Final Report - Approved

Permit or Case Number:20240829-042

Description : New construction of a single-family dwelling with an attached garage.

LEHOIST RESIDENCE

COVER PAGE

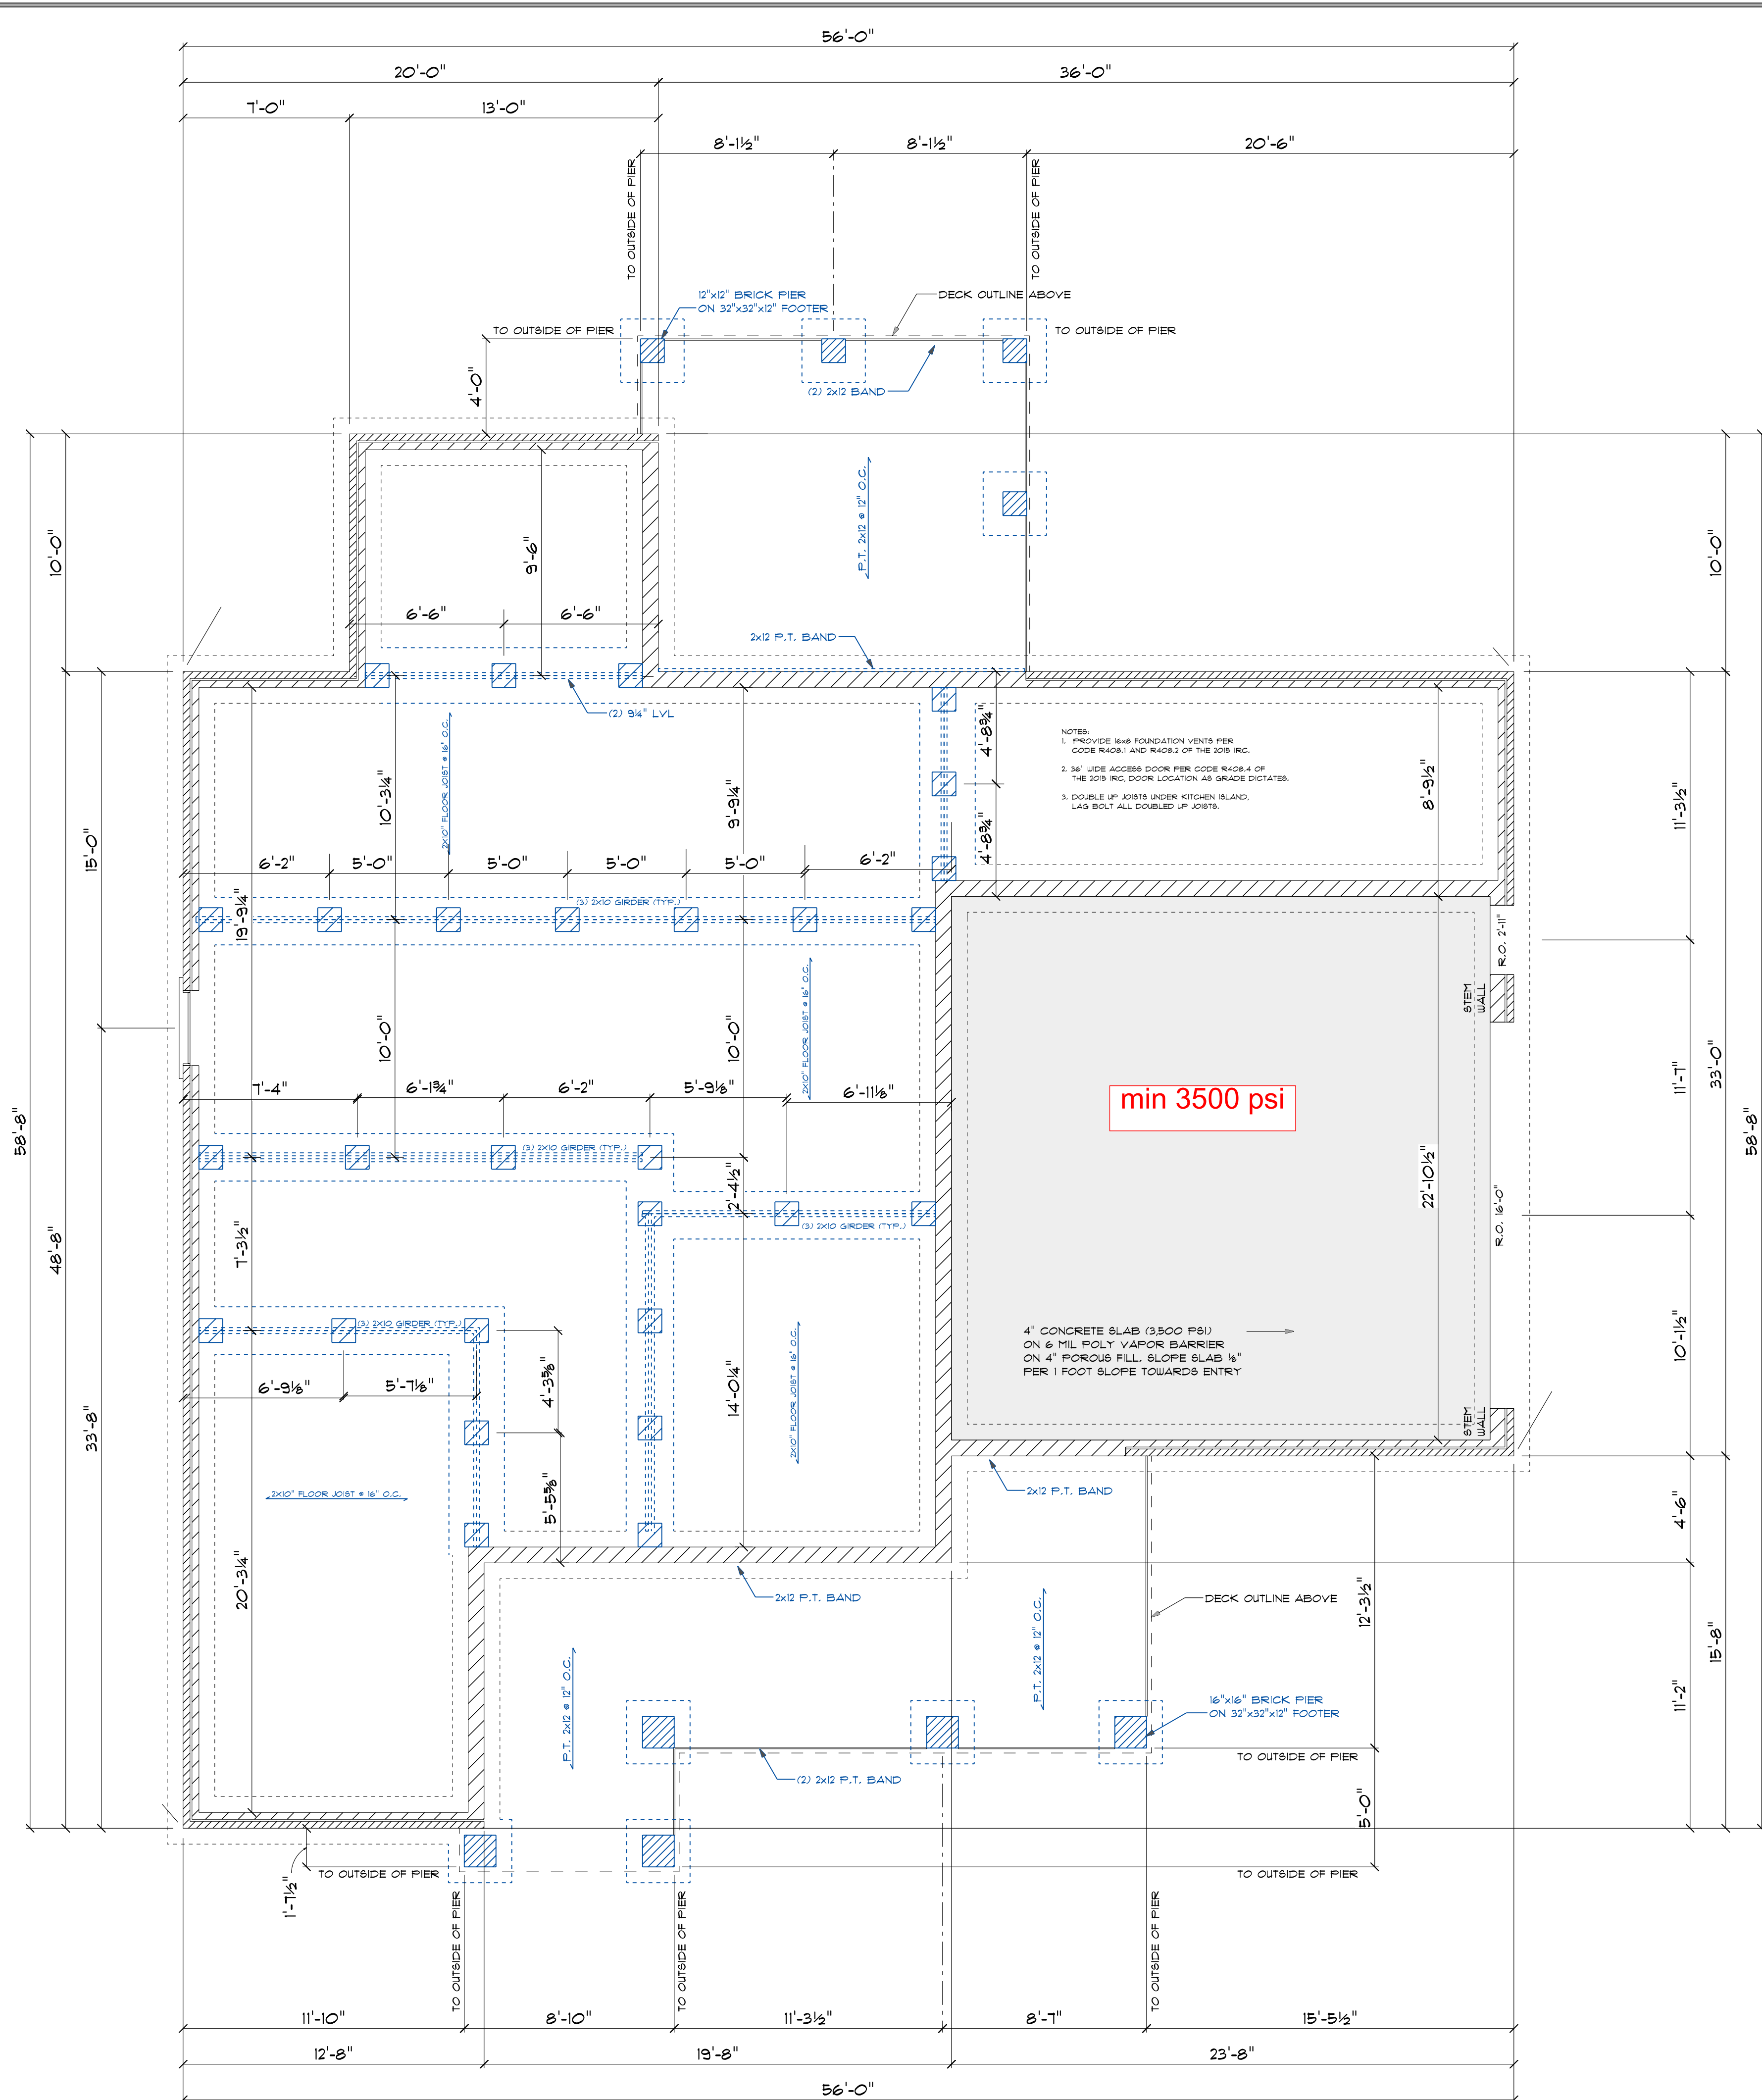
Gutters Required Per VRC Section R801.3

MULLED WINDOW DETAIL
SCALE: 1/4" = 1'-0"

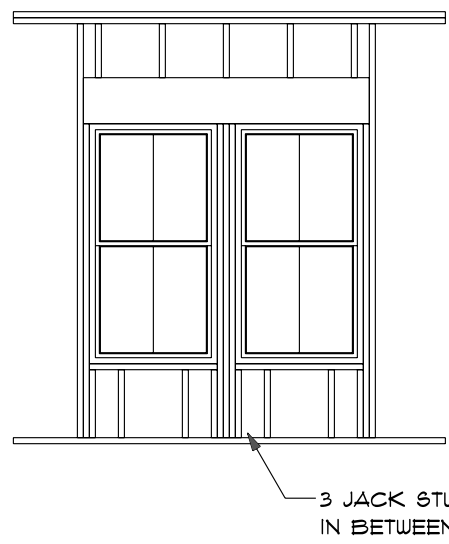
tempered if within 36" of landing

TYPICAL LARGE SCALE WALL SECTION
SCALE: 1" = 1'-0"

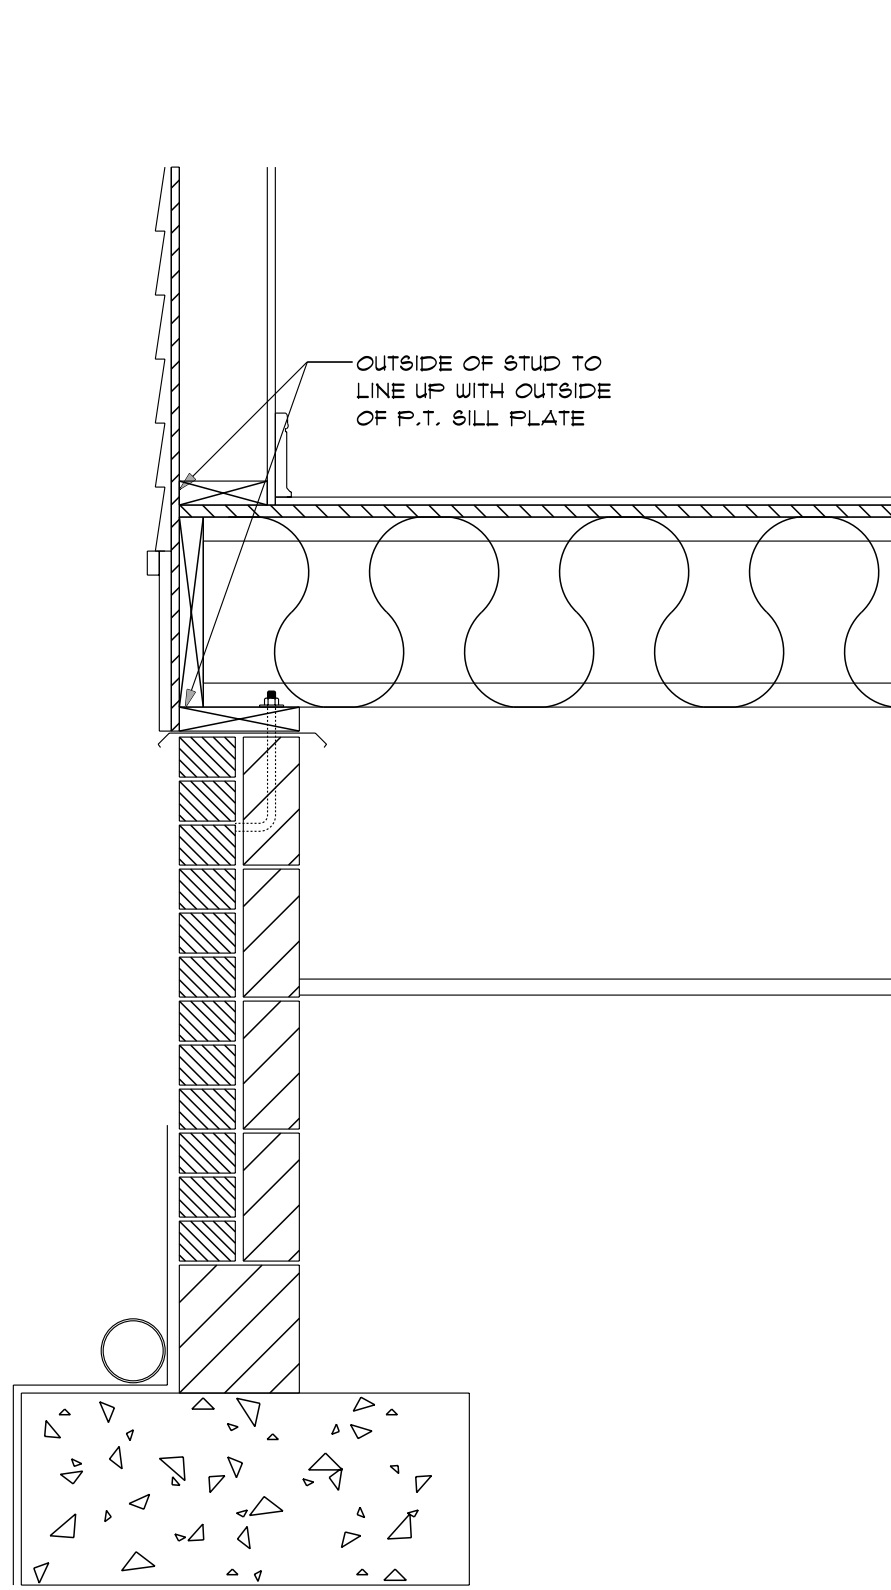
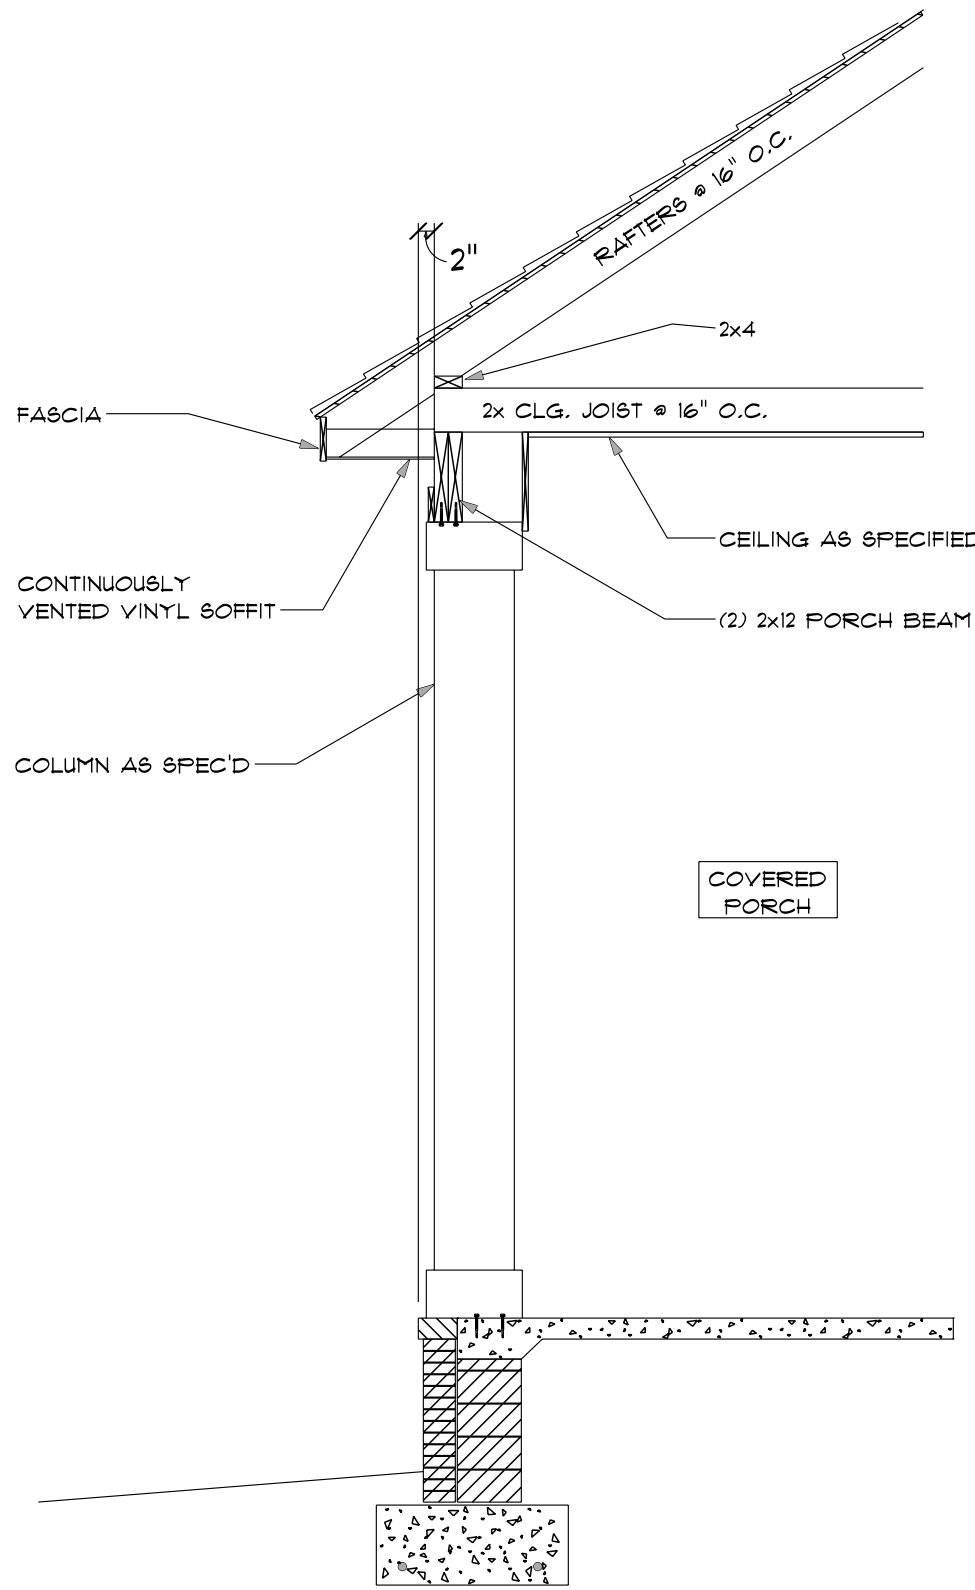
Minimum Insulation Values
R-15 Walls
R-19 Floor
R-49 Ceiling
R-10 Perimeter Slab

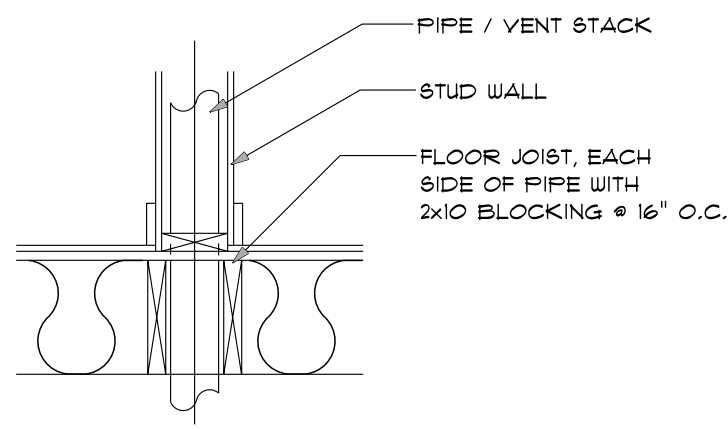
1/2" Anchor Bolts to be in Center
of CMU Block, 12" max. From Sill
Plate Ends and 6' max. o.c.
